MILITARY SPECIFICATION
DETECTING SET, MAGNETIC AN/ASQ-81(V)

This amendment forms a part of MIL-D-81609C(AS), dated 23 July 1981, and is approved for use by the Naval Air Systems Command, Department of the Navy, and is available for use by all Departments and Agencies of the Department of Defense.

*FIGURE 4. RANDOM VIBRATION SPECTRUM

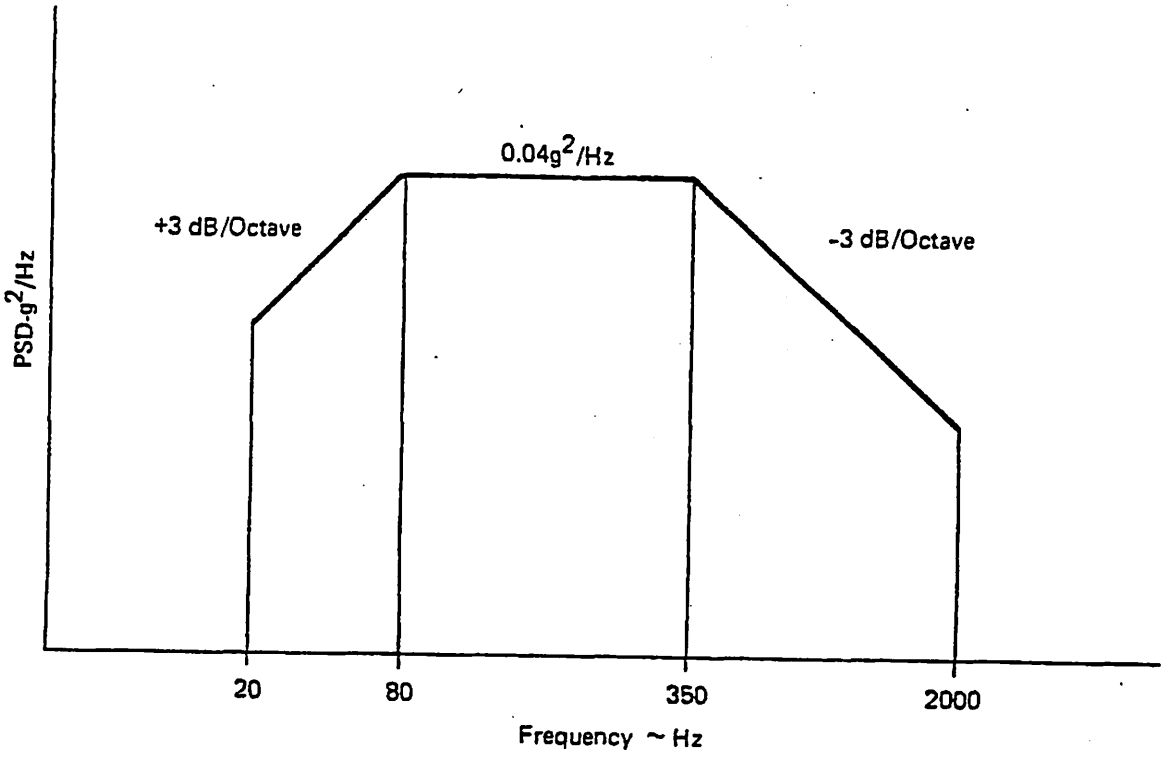
*4.4.1.3 Manufacturing Screening - Each equipment shall undergo 10 minutes of random vibration per Figure 4. The vibration shall be applied perpendicular to the plane of the printed circuit boards in a minimum of two axis for all electronic modules, SRA's, and WRA's including SRA's on the reeling machine. If different planes exist, the vibration shall be applied to each axis for 10 minutes. After completion of random vibration, each module, SRA and WRA shall be examined carefully to determine that materials and workmanship

*Figure 4 - Add Figure 4.
